Index 536-001 Guardrail

COMMENTARY

COMMENTS AND RESPONSES

POST AND OFFSET BLOCK DETAILS

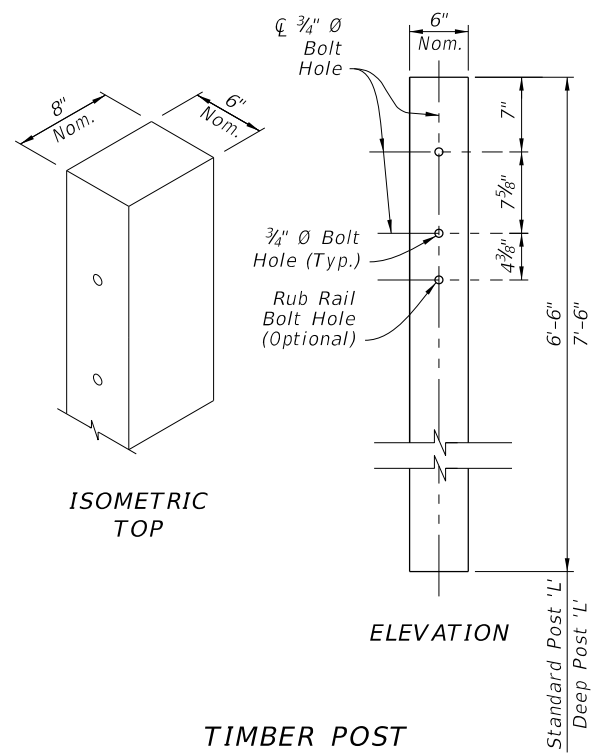
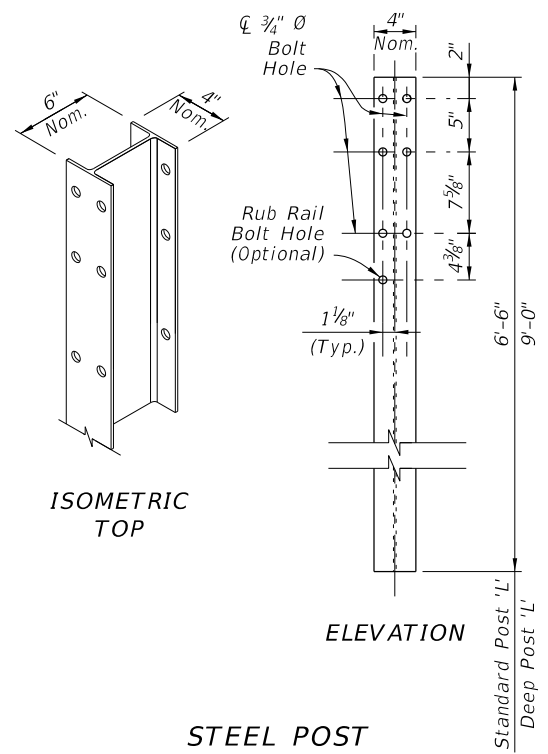
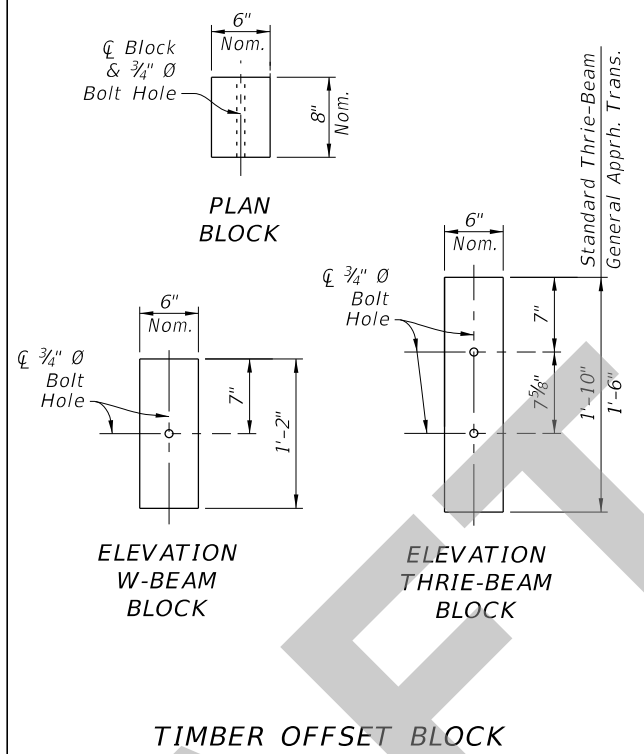
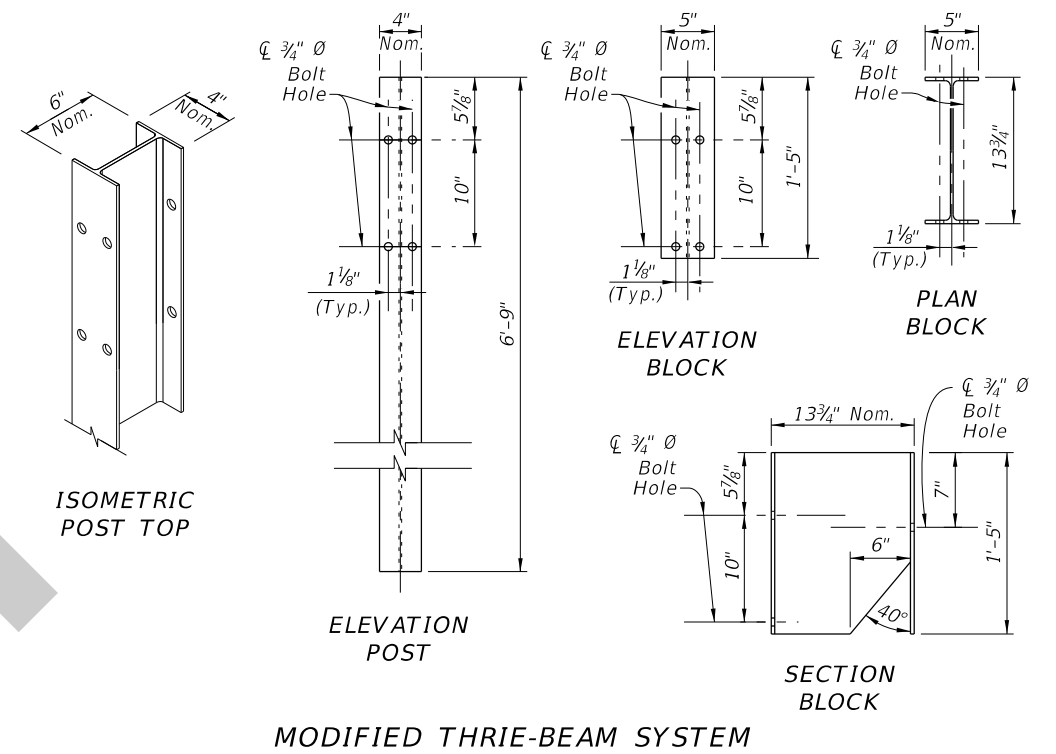
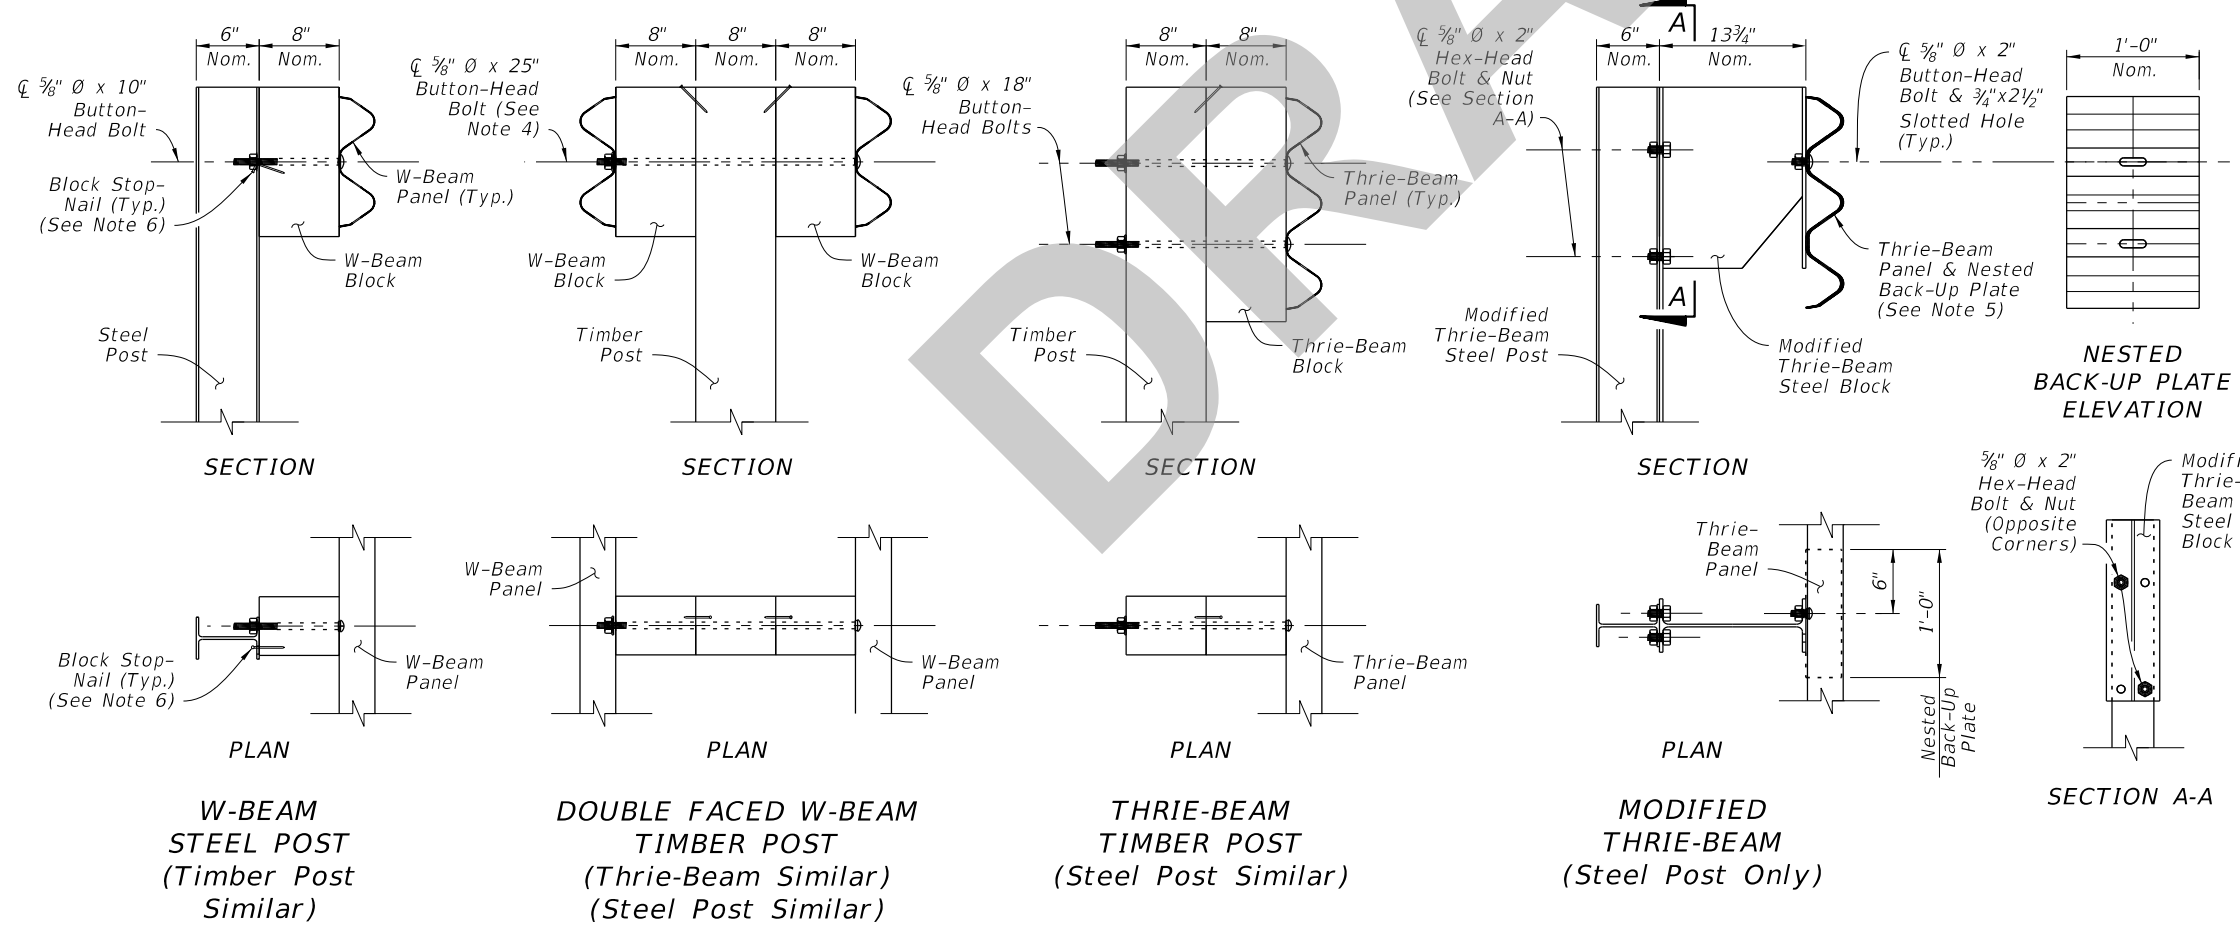
Sheet 5: Can the Rub Rail bolt hole remain in place without using Rub Rail? This would help in stockpiling a single post type with all holes in place.

Agreed. The Rub Rail callout will change from (If Req'd.) to (Optional) to allow posts both with and without the bolt hole when no rub rail is used.

END TREATMENT - COMPONENT DETAILS

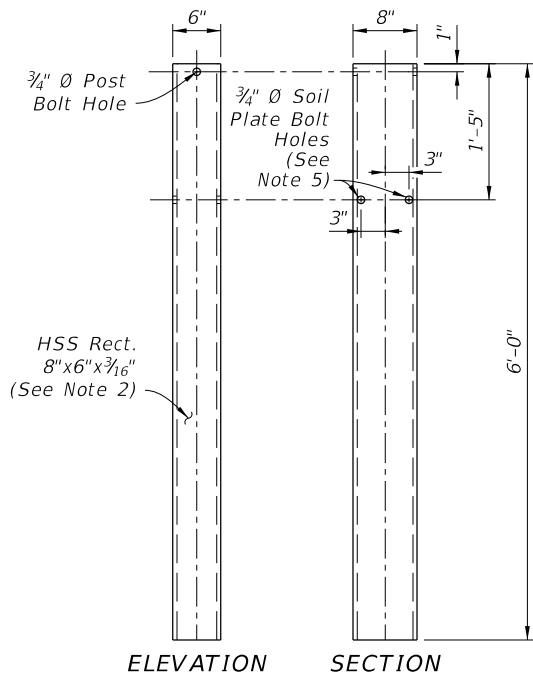
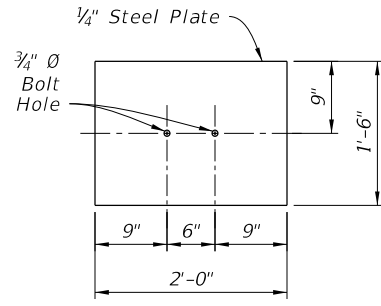
Sheet 10: For Trailing Anchorages, can the Soil Plate Bolt Holes in the Steel Tube Foundation be substituted with a single hole on the tube centerline when only one bolt is needed? This would help align the post configuration with other states.

Agreed. The option for using a single Soil Plate Bolt Hole on the CL of steel tube for the Trailing Anchorage condition will be permitted per new Note 5.

5. SOIL PLATE BOLT HOLE(S): For Trailing Anchorage installations as shown on Sheet 9, the two bolt holes shown may be substituted with a single bolt hole located at the tube centerline.
